Benton County Planning Board

**COMMERCIAL/INDUSTRIAL LARGE SCALE DEVELOPMENT:
PLANNER'S TECHNICAL REPORT
ILLINOIS RIVER, SILOAM SPRINGS, AR**

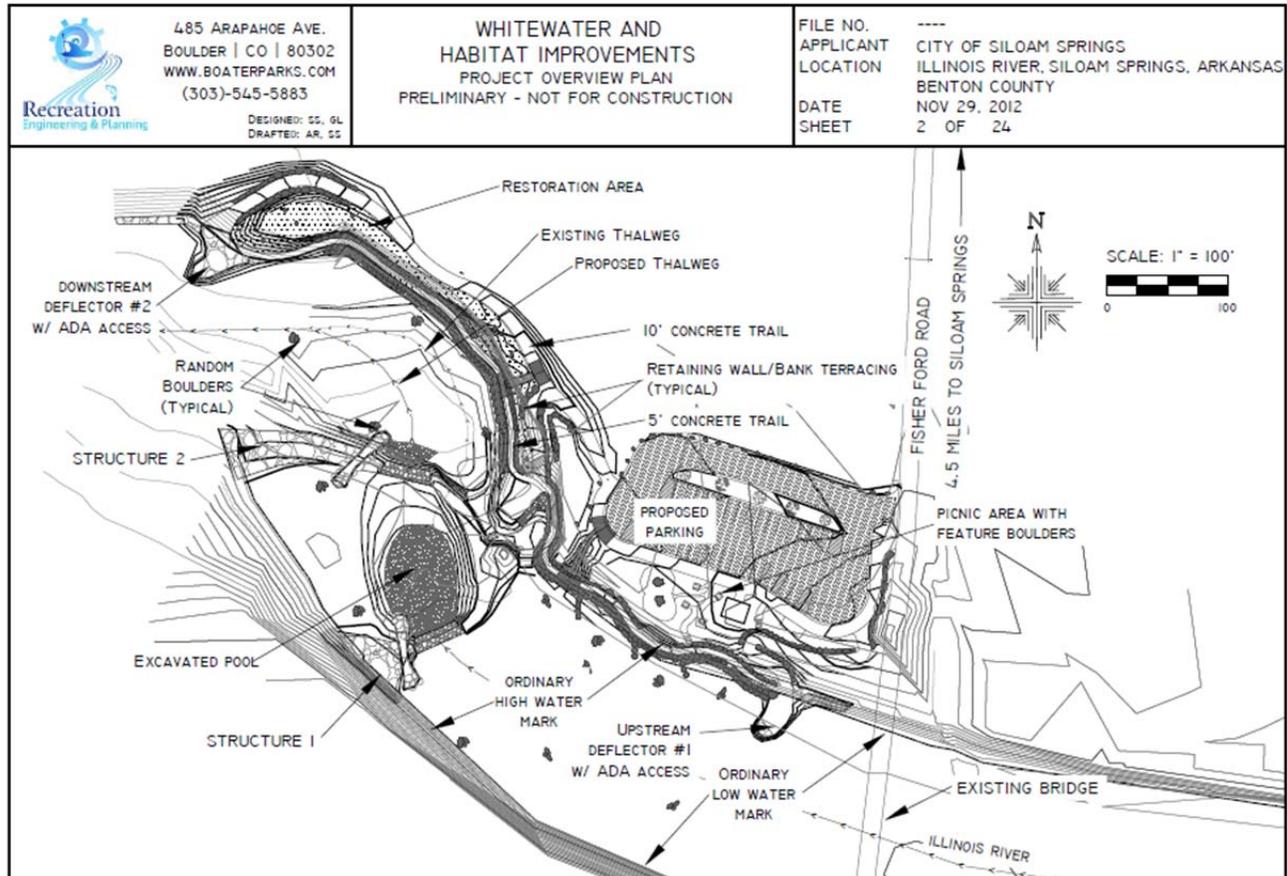
1. **Provision regarding removal of portable toilets during flooding**
2. **State or federal permits associated with the proposed development, such as, the Short Term Activity Authorization (STAA) and Notice of Intent (NOI) from ADEQ, Wetland Permits etc. The NOI needs to be posted on-site along with the SWPPP.**

-
3. **Applicant to note that the service agreement refers to parcel No. 18-13187-001 only. This is a triangular parcel along the south end only. Parcel No. 18-13173-001 relates to the overall project area and should be referenced unless the two parcels re to be consolidated.**
 4. **Applicant is required to submit a Stormwater report from a certified registered engineer in Arkansas conforming that the storm water run-off is restricted to pre development flow.**
 5. **Applicant to provide service agreement for electrical power supply.**
 6. **Applicant to provide copies of all state and federal permits already obtained for this project.**
 7. **Applicant to confirm City of Siloam Springs lighting plan as noted in the cover letter dated May 31, 2013.**
